**TOWN OF MONTAGUE**  
**Invitation to Bid**  
**Montague Center Library Window Replacement Project**  
17 Center Street  
Montague, MA 01351

**ADDENDUM #1**  
**Issued 2/15/2024**

### Second Story Balcony Flooring

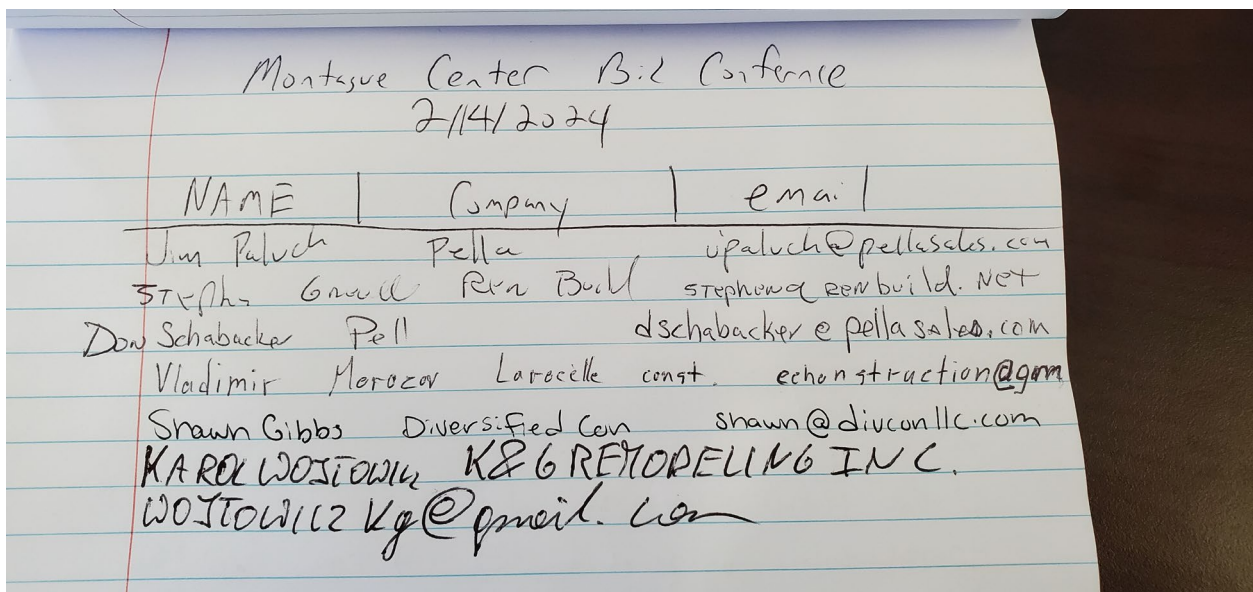
The second story front windows butt up against the floor of the balcony. Limited removal of balcony flooring will be permitted to accommodate the window install, subject to the approval of the project manager.
